# DEVELOPMENT REVIEW BOARD REPORT

MEETING DATE: January 5, 2006

SUBJECT	<b>Baraca Estates 18-PP-2005</b>
REQUEST	Request approval of a Preliminary Plat for a 16-lot, Single-Family Residential subdivision, with amended development standards.
OWNER	C. Don Fowler
APPLICANT CONTACT	Cindy Deonti Kimley-Horn & Associates, Inc. 602-906-1176
LOCATION	Northwest corner of Pima and Hawknest Roads.
BACKGROUND	<p><b>Zoning.</b></p> <p>The site is zoned R1-43 ESL. This single-family residential zoning allows single-family dwelling units with 43,000 square foot lots. The Environmentally Sensitive Lands zoning encourages the preservation of natural features and open space and also allows amended development standards.</p> <p><b>Context.</b></p> <p>This site is located on the west side of Pima Road, between Woodley Way and Hawknest Road. This parcel has some rolling hills and washes crossing from the east to west. The existing site improvements are located to the northwest side of the site and include a residence and equestrian improvements.</p> <p><b>Adjacent zoning and uses.</b></p> <p>The area east of Pima Road is planned for Preserve purposes and is unimproved. The properties on the other sid

# BUILDING ENVELOPE CONCEPT PLAN FOR BARACA ESTATES SCOTTSDALE, AZ

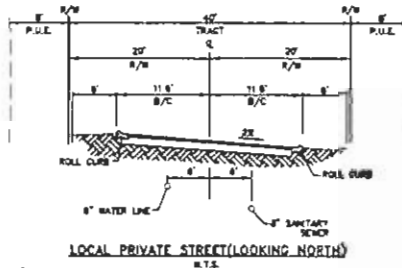
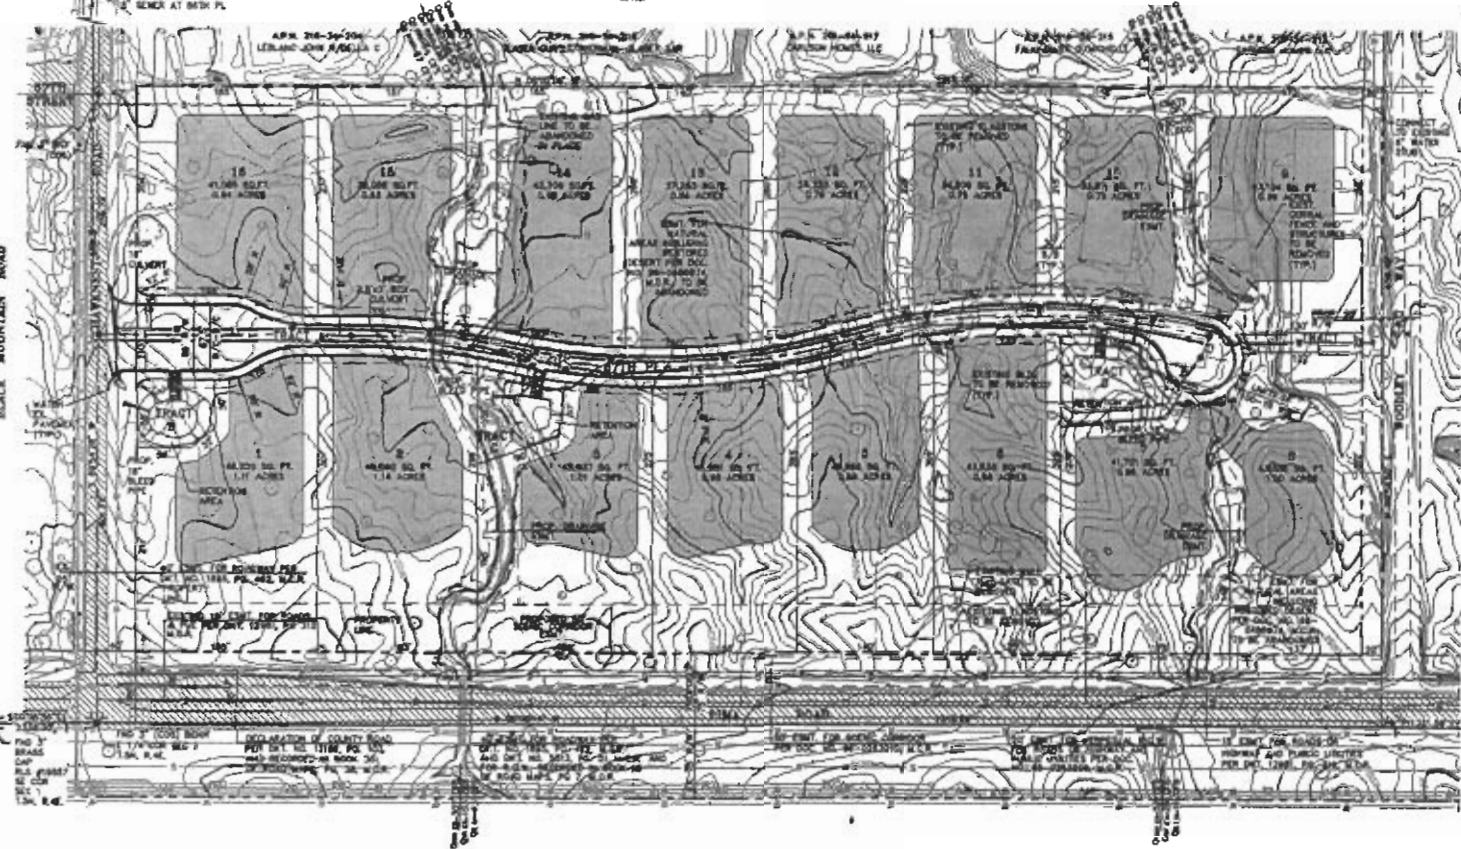
To fully accomplish the flexible intent of the Scenic Corridor Design Guidelines, the proposed building envelope of Lot 7 and 8 should be adjusted. Lot 8 is proposed with an 80-foot building envelope setback, but could be set at 50-feet along its north side and 72-feet at its south lot line. Lot 7 is proposed with a building envelope at its minimum distance allowing a 65-foot Scenic Corridor, but which should taper from 72-feet on its north side to 100-feet on its south side.

8. *The building envelop of Lot 6 shall be revised to an organic form from its currently proposed rectangular shape.*
9. *Areas of drainage easements, scenic corridor/trail easement, NAOS, and areas within the 100-year high water elevation (HWE) of any wash of 50 cubic feet per second (cfs) or greater pre-development flow shall not be included within the building envelope of any lot.*

The applicant has agreed to adjust the building envelope to conform with the Scenic Corridor Design Guidelines 1:3 taper and a stipulation is included to assure this is part of the final plat design.
